Access Compliance Report Public Rights-of-Way (Curb Ramps)

Main Street: ABELIA_ST		Cross Street: STRAWFLOWER_ST		Location:	S
ADA ID: RPAT211102135612	Ramp Type: Type 4 - Parallel	Initial Pass/Fail: Fail	Overall Compliance: No	Severity Score:	16

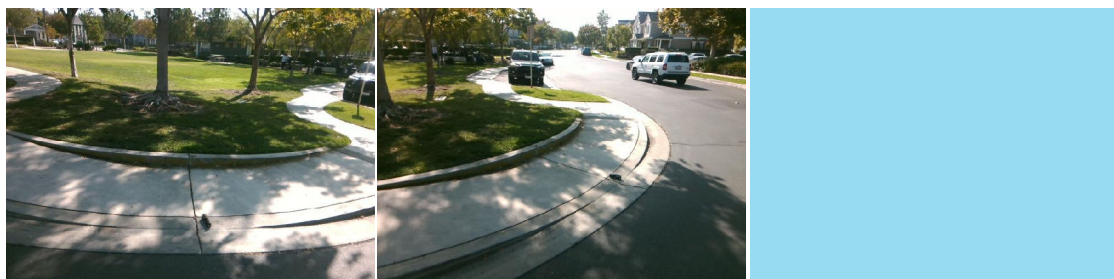
R204.3, R304.3.2, R304.5.3, STD 1115

Compliance	Description	Data	Compliance	Description	Data
N/A	Ramp Length LT (in)	105	N/A	Ramp Length RT (in)	105
Yes	Ramp Width LT (in)	54	Yes	Ramp Width RT (in)	54
No	Ramp Run Slope LT (%)	10	Yes	Ramp Run Slope RT (%)	1.4
No	Ramp Cross Slope LT (%)	2.8	No	Ramp Cross Slope RT (%)	2.3
N/A	Landing Present	N/A	N/A	DWS Provided	N/A
N/A	Landing Length (in)	N/A	N/A	DWS Contrast	N/A
N/A	Landing Width (in)	N/A	N/A	DWS Length (in)	N/A
N/A	Landing Run Slope (%)	N/A	N/A	DWS Full Width	N/A
N/A	Landing Cross Slope (%)	N/A		DWS Offset Type	N/A
N/A	Landing Movement Obstructed?	N/A	N/A	DWS Offset Left (in)	N/A
	Landing Movement Type	N/A	N/A	DWS Offset Right (in)	N/A
N/A	Landing Shared	N/A			
N/A	Clear Space	Yes			
N/A	Clear Space To Crosswalk (in)	N/A			
N/A	Marked Crosswalk 1	No	N/A	Marked Crosswalk 2	No
	Crossing 1 Direction	NE		Crossing 2 Direction	NW
N/A	Marked Crosswalk 1 Width (in)	N/A		Marked Crosswalk 2 Width (in)	N/A

Remove & Replace Curb Ramp With Two New Directional Ramps or Equivalent.
